**NEXTERA ENERGY POINT BEACH, LLC
POINT BEACH NUCLEAR PLANT, UNITS 1 AND 2**

**LICENSE AMENDMENT REQUEST 261
EXTENDED POWER UPRATE**

NON-PROPRIETARY RESPONSE TO REQUEST FOR ADDITIONAL INFORMATION

December, 2009

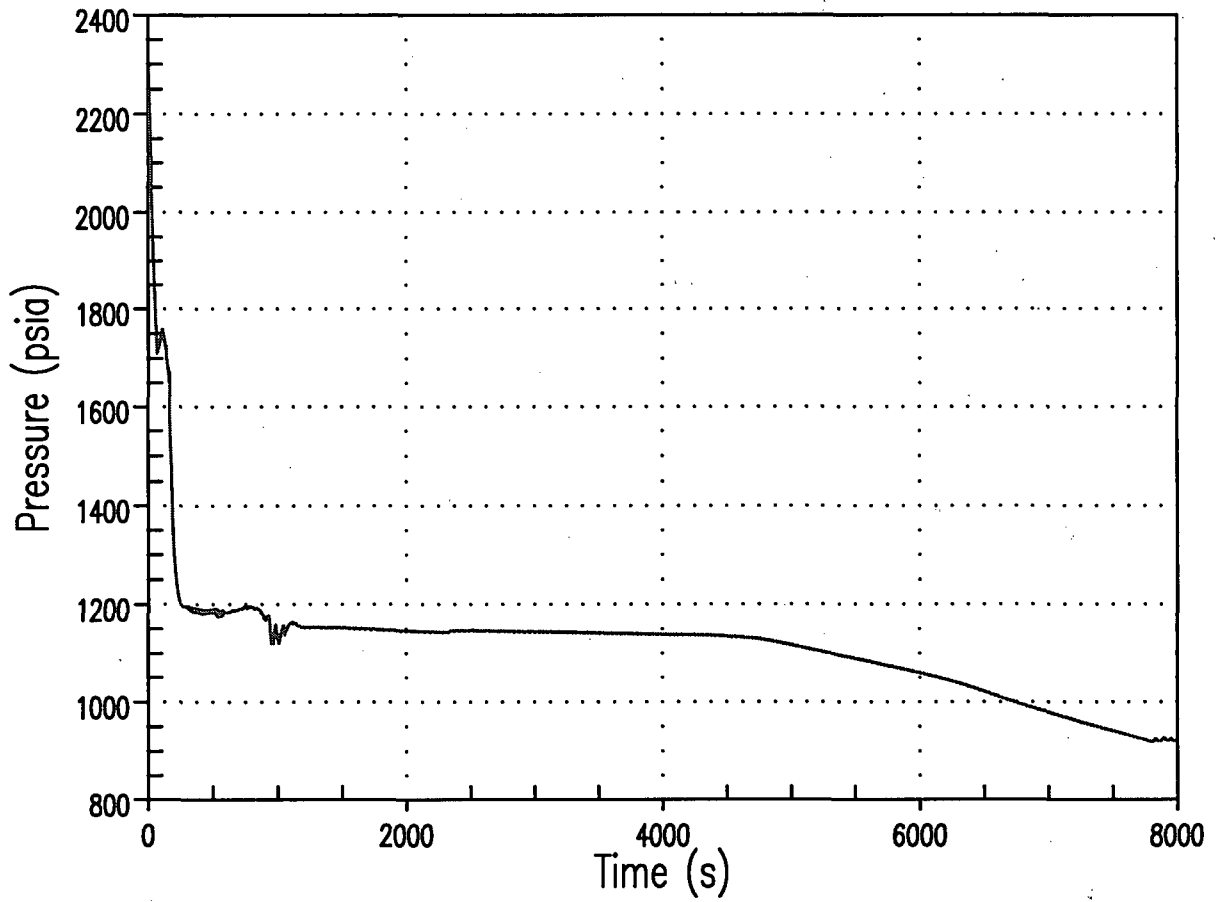
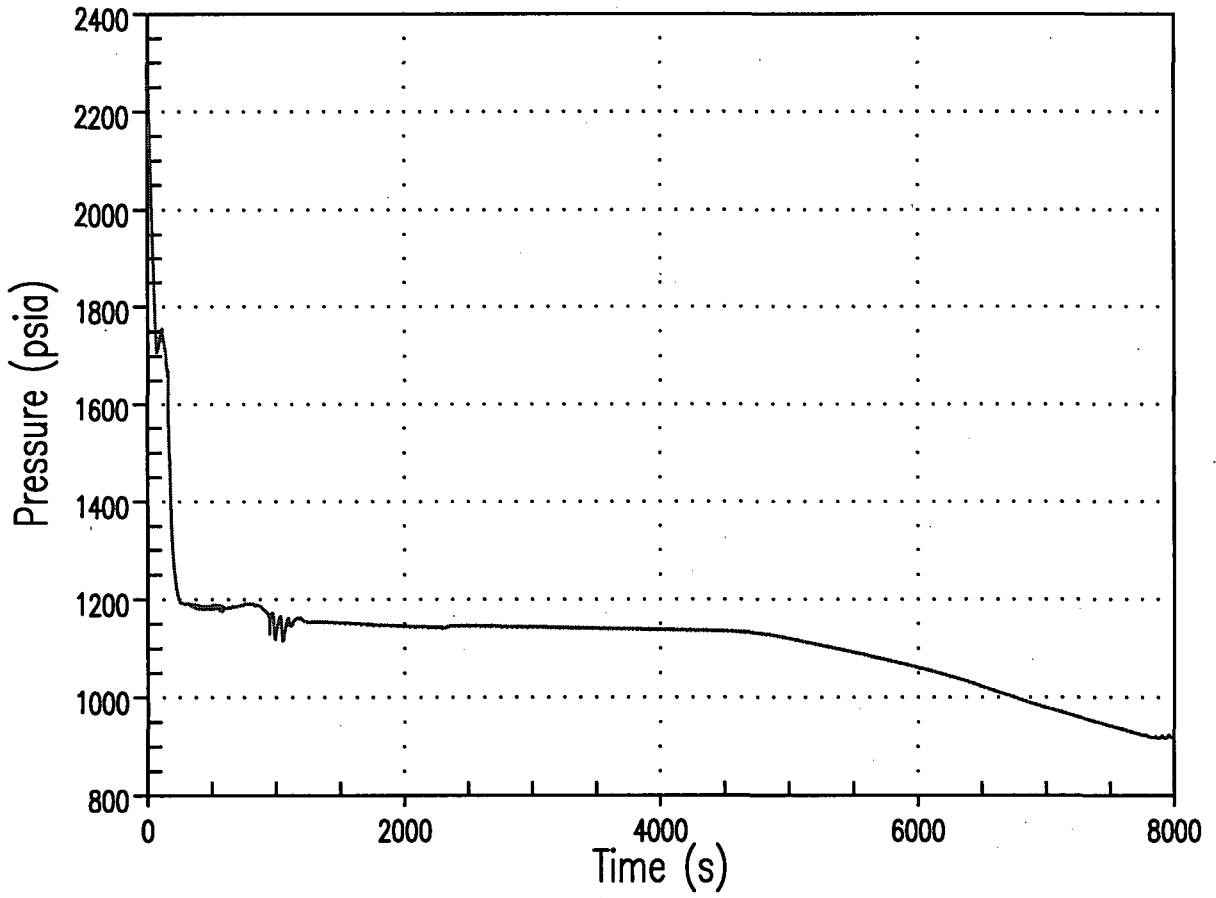
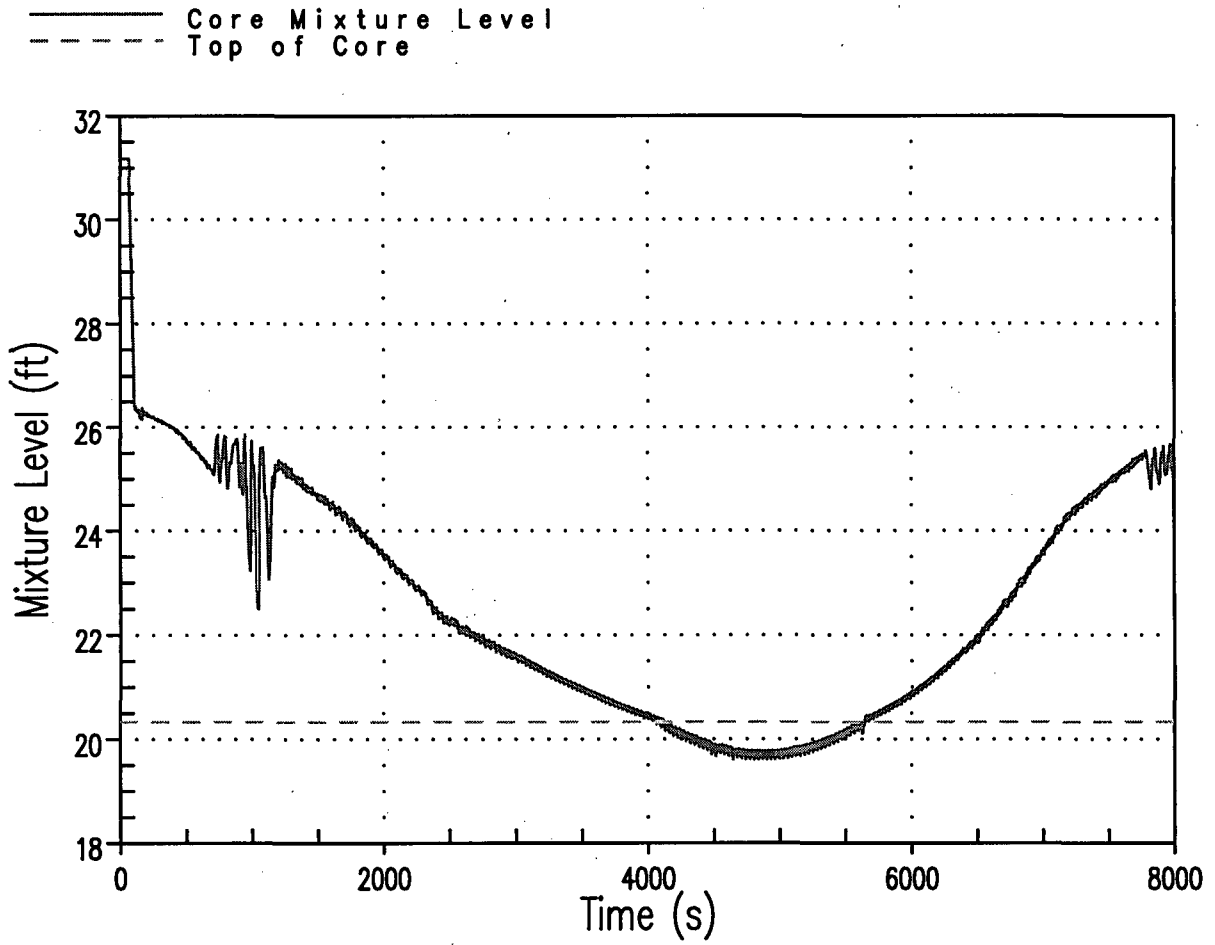
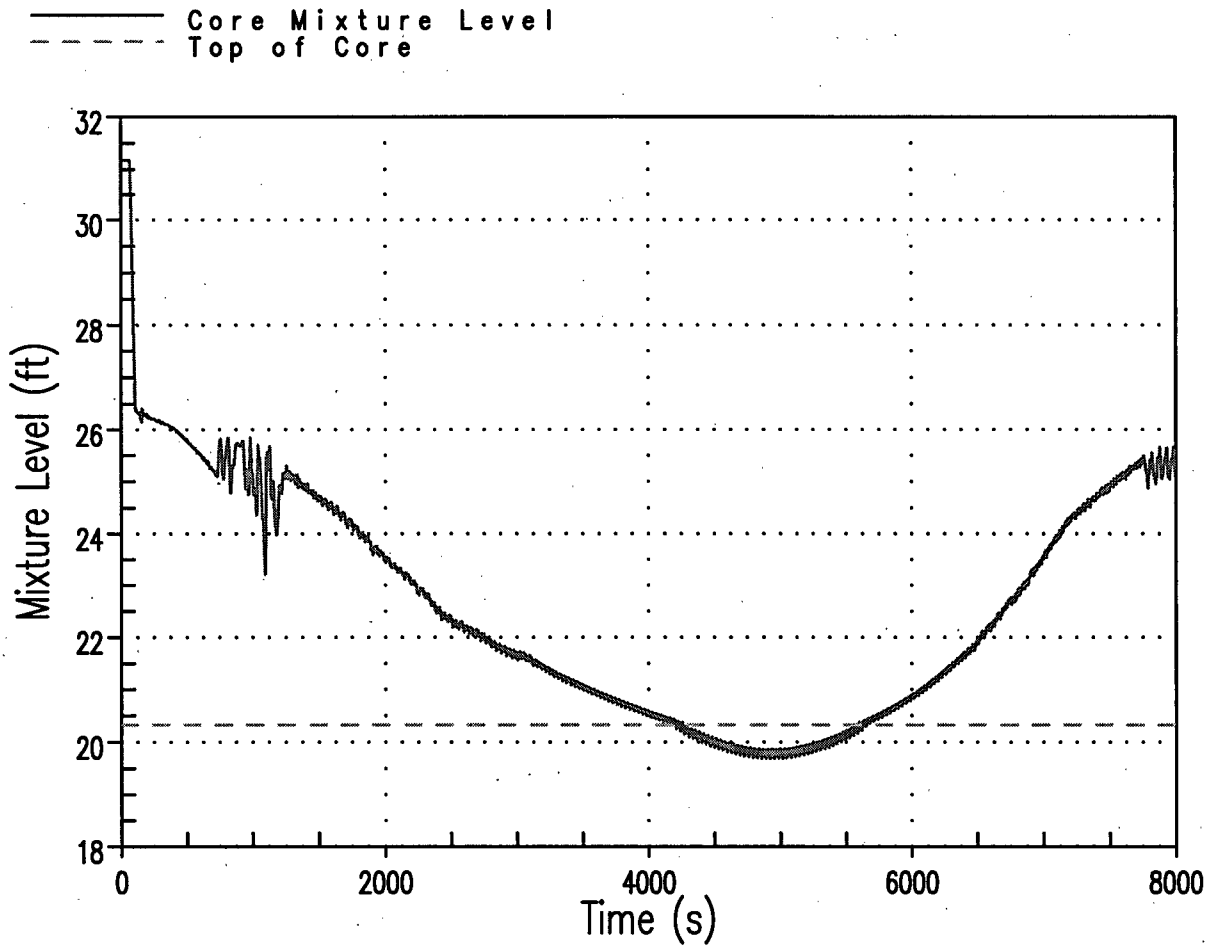
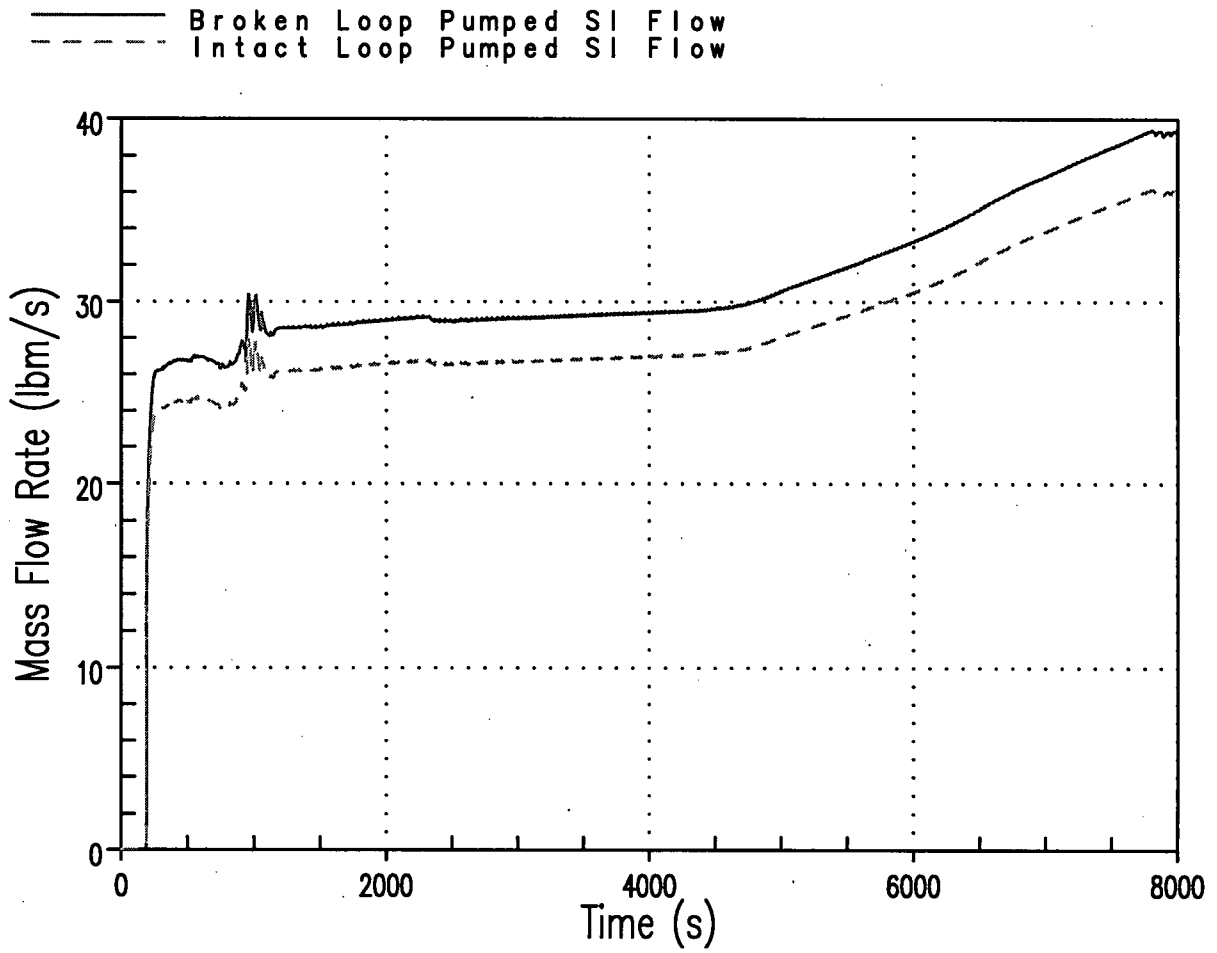
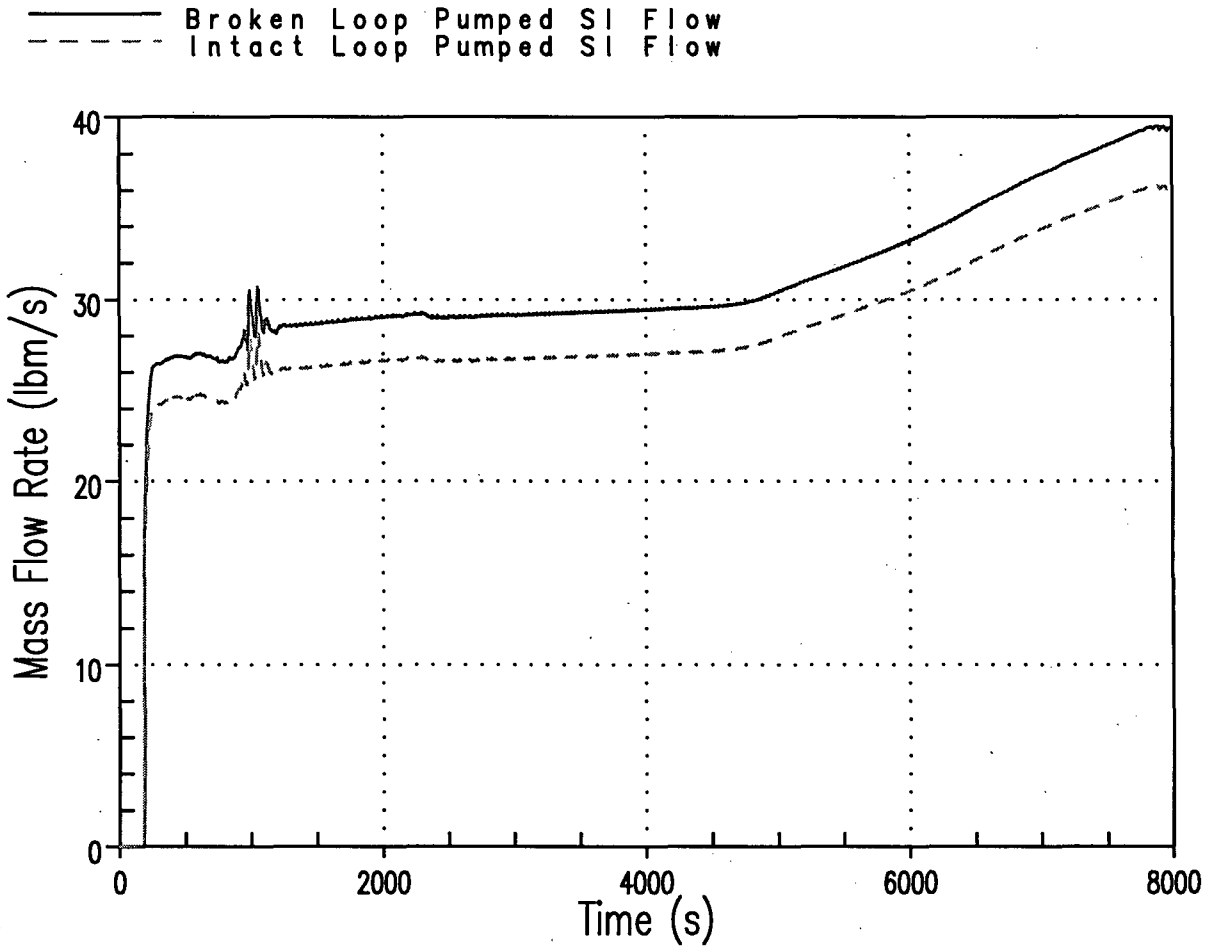
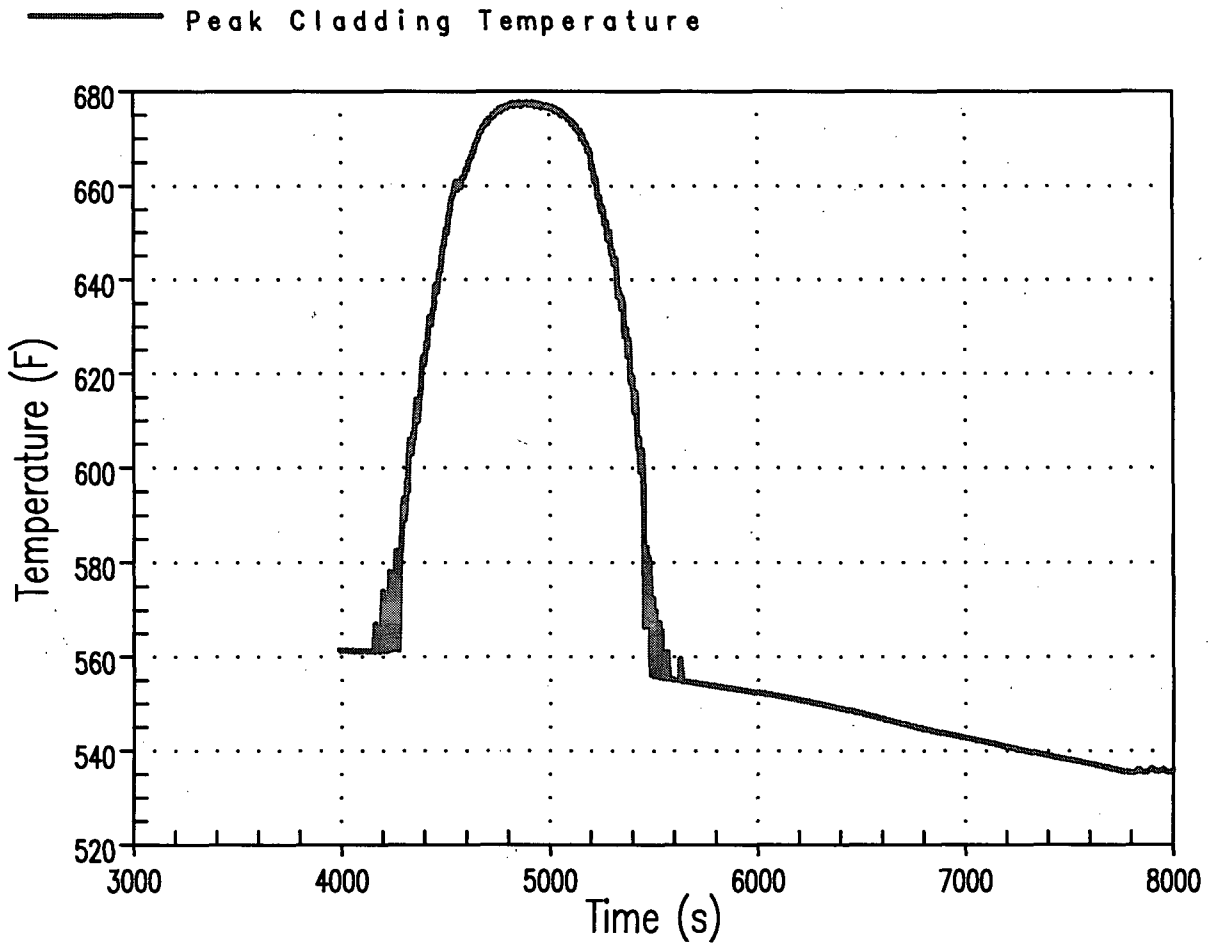
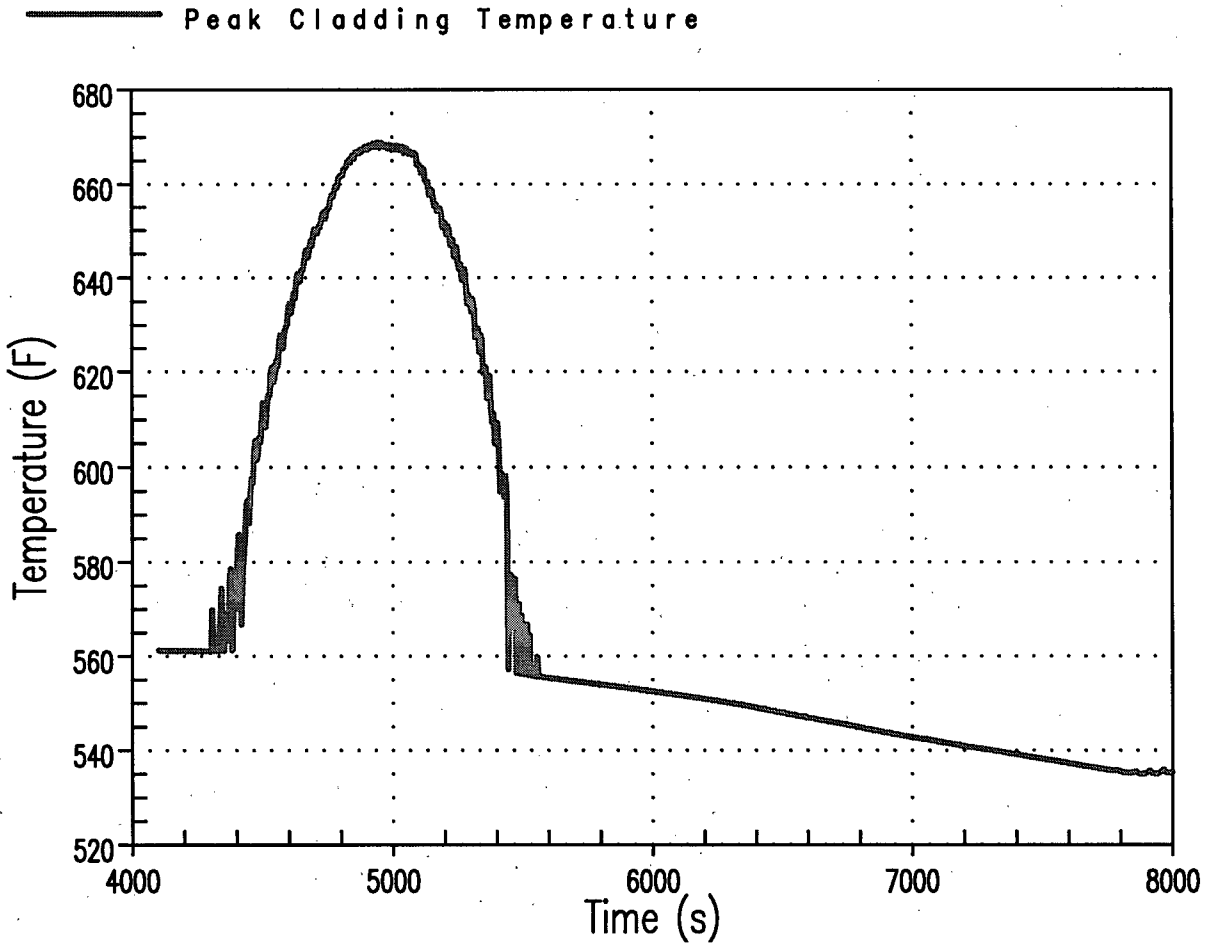
- 1) Page 2.8.5.6.3-6 of the Point Beach Extended Power Uprate (EPU) Licensing Report (Enclosure 5 to Reference 1) indicates that the small-break loss-of-coolant accident analysis was performed using the NOTRUMP evaluation model. Please provide a copy of the NOTRUMP analysis report that supports the EPU application.**

The NRC reviewer provided clarification of this RAI during a teleconference held between Westinghouse, FP&L, and the NRC. It was concluded that the transient response results of the non-limiting breaks, which are not provided in the LAR, will be provided. Transient response results for the limiting 3-inch break for both Point Beach Units 1 and 2 are provided in the small break LOCA LAR Section 2.8.5.6.3. The same response results for the non-limiting breaks are provided below. The following comments apply:

- Peak cladding temperature transients are not provided for the 6- and 8.75-inch breaks as these breaks experienced little to no core uncover.
- Low head safety injection flow figures are provided only for the 6- and 8.75-inch breaks. LHSI was only modeled for the 6- and 8.75-inch breaks (during RWST injection phase only). Breaks less than 6-inches in equivalent diameter did not reach the LHSI cut-in pressure.
